Subject: Request for Additional Information - Palo Verde Emergency Plan

Request for Additional Information  
For Palo Verde Nuclear Generating Station Emergency Planning Items

## COMMENTS ON EALS

# FLOW CHART FOR GENERAL EMERGENCY OFFSITE PROTECTIVE DECISIONS

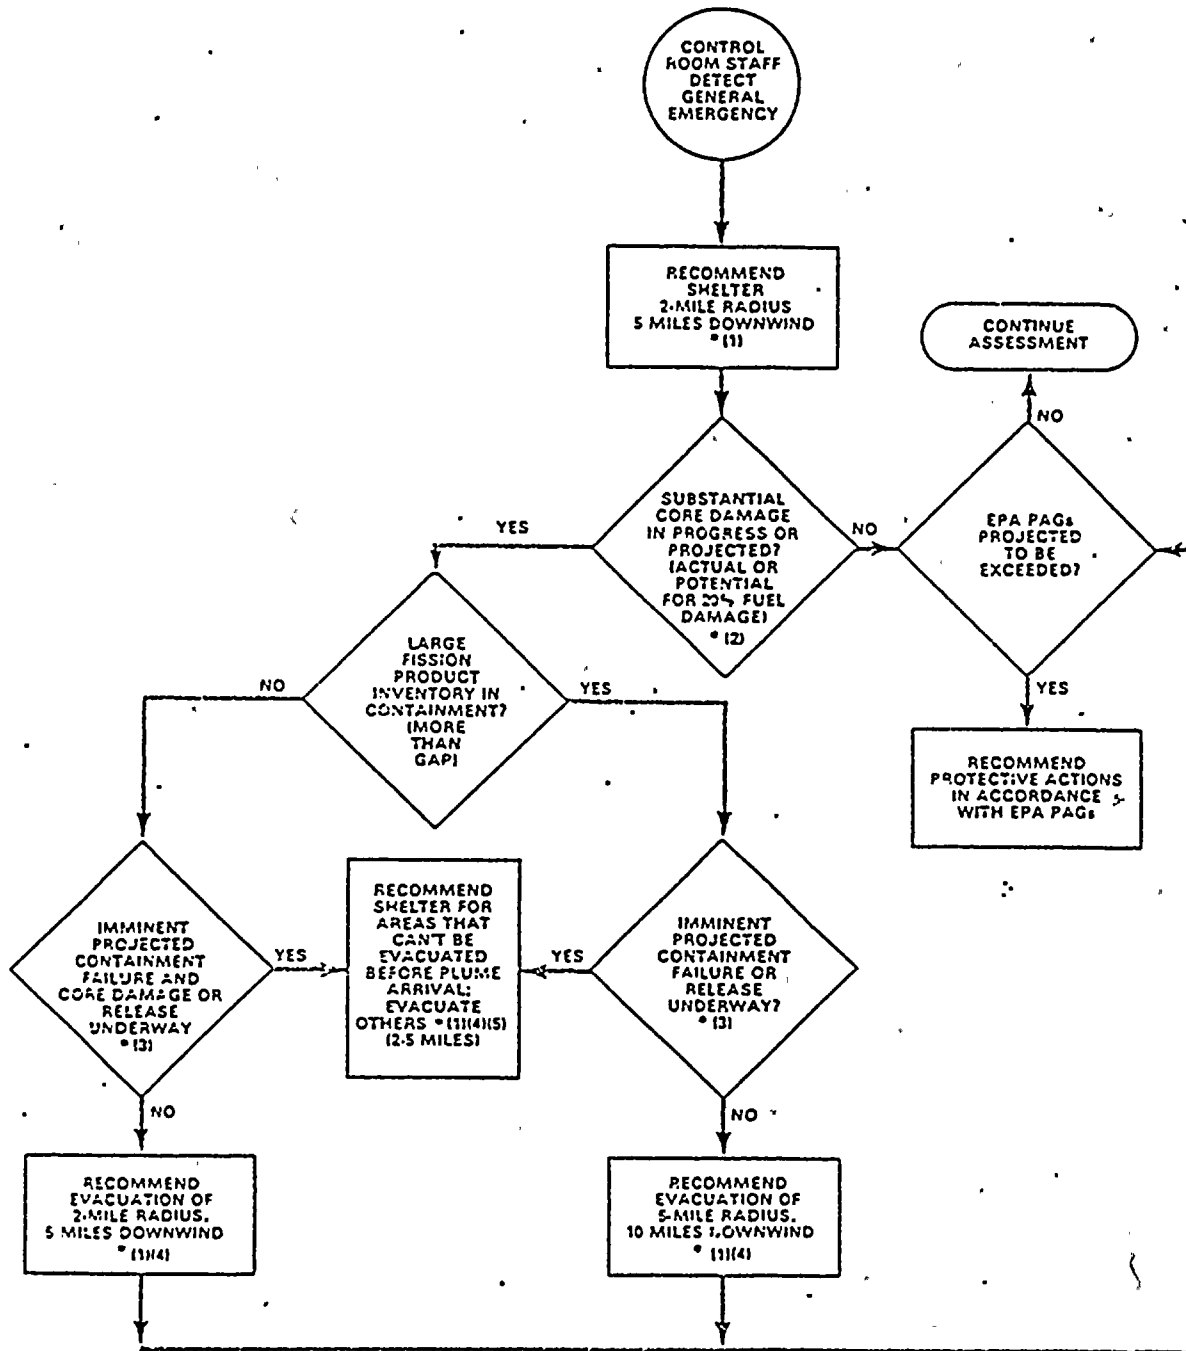
In order to aid in this task, two attachments are included: (1) protective action decision flow chart (2) 82-38 information notice on EALs. With respect to protective action decision making in general as it concerns General Emergencies, each decision point "◇" on the flow chart should be associated with EALs.
